TE Connectivity

Product Change Notification: PCN-22-161841

AMP MCP 1.5K PRODUCT GROUP DRAWING

Before Dimension (Dwg Rev B23)

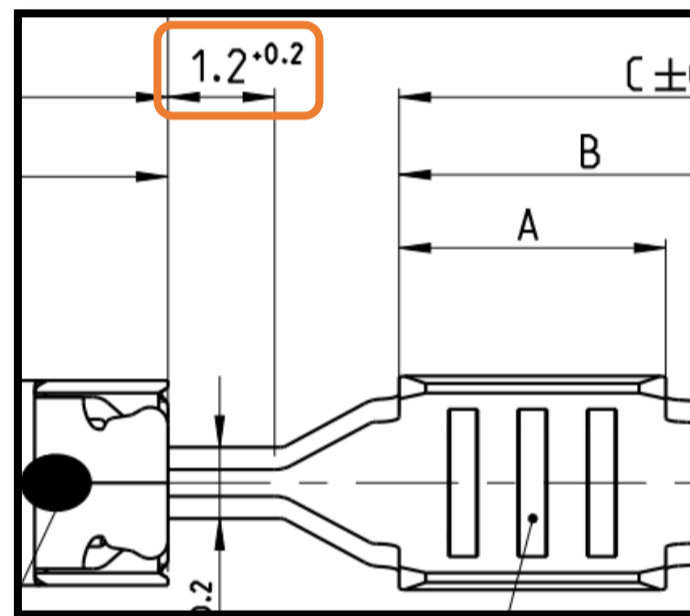
The tolerance extension of the transient area (neck) between body's head and wire crimp.
The current DIM "1.2+0.2" in sector C7 in CD will be changed to "MIN. 1.2".
This is not FFF change, functionality of the secondary lock will not be affected.
This is correction of the current state acc. the production from the initial release.
